PIC24FJ64GA104 Family Silicon Errata and Data Sheet Clarification

The PIC24FJ64GA104 family devices that you have received conform functionally to the current Device Data Sheet (DS39951C), except for the anomalies described in this document.

Data Sheet Clarifications

The following typographic corrections and clarifications are to be noted for the latest version of the device data sheet (DS39951C):

FIGURE 2-3: FREQUENCY vs. ESR PERFORMANCE FOR SUGGESTED VCAP

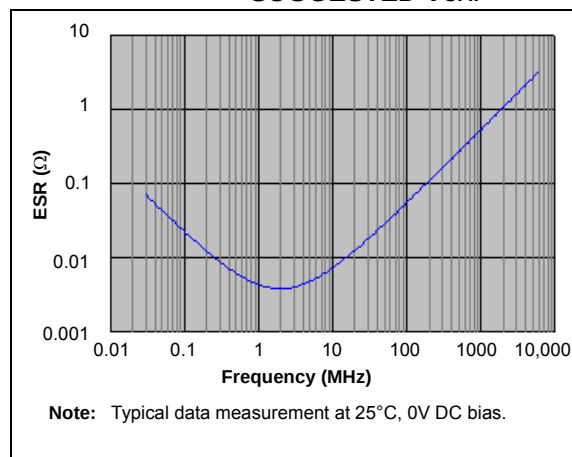
Section 2.4 “Voltage Regulator Pins (ENVREG/ DISVREG and VCAP/VDDCORE)” has been replaced with a new and more detailed section. The entire text follows:

When the regulator is enabled, a low-ESR ($< 5\Omega$) capacitor is required on the VCAP/VDDCORE pin to stabilize the voltage regulator output voltage. The VCAP/VDDCORE pin must not be connected to VDD and must use a capacitor of 10 μF connected to ground. The type can be ceramic or tantalum. Suitable examples of capacitors are shown in [Table 2-1](#). Capacitors with equivalent specifications can be used.

Designers may use [Figure 2-3](#) to evaluate ESR equivalence of candidate devices.

FIGURE 2-4: DC BIAS VOLTAGE vs. CAPACITANCE CHARACTERISTICS

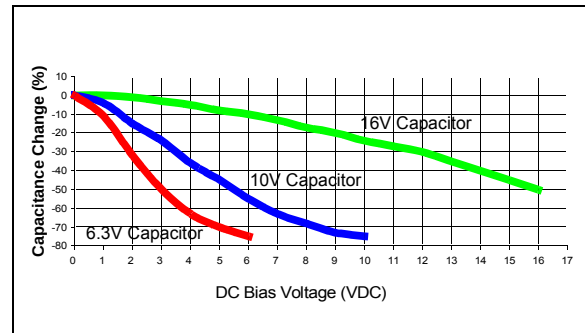
In addition to temperature tolerance, the effective capacitance of large value ceramic capacitors can vary substantially, based on the amount of DC voltage applied to the capacitor. This effect can be very significant, but is often overlooked or is not always documented.

A typical DC bias voltage vs. capacitance graph for 16V, 10V and 6.3V rated capacitors is shown in Figure 2-4.

When selecting a ceramic capacitor to be used with the internal voltage regulator, it is suggested to select a high-voltage rating, so that the operating voltage is a small percentage of the maximum rated capacitor voltage. For example, choose a ceramic capacitor rated at 16V for the 2.5C core voltage. Suggested capacitors are shown in Table 2-1.
